# Service Bulletin

4-STROKE  
BULLETIN VS/VX/VZ/VL NO. 39  
DATE: 4/27/2006

**SUBJECT:** OWNER'S MANUAL CORRECTION - SUSPENSION ADJUSTMENT

**MODEL:** VZR1800K6

## SUSPENSION ADJUSTMENT

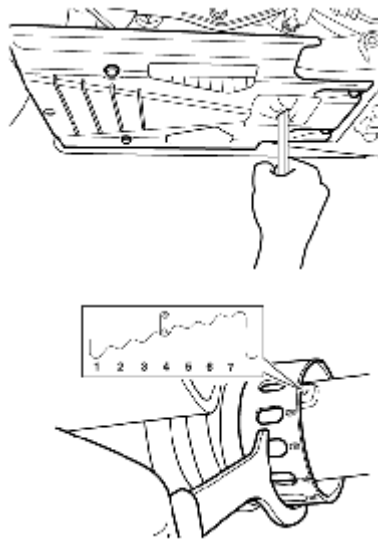
2. Twist the spring tension ring to the desired position ~~with the adjuster provided in the tool kit~~. Position 1 provides the softest spring tension and position 7 provides the stiffest. This motorcycle is delivered from the factory with its adjuster set on position 4.

← Delete "with the adjuster provided in the tool kit"

Note: Use a hook spring type adjuster or Suzuki spring adjuster (Part Number 09822-00003) to adjust the rear suspension spring. The Suzuki spring adjuster is available from your Suzuki dealer.

← Add note
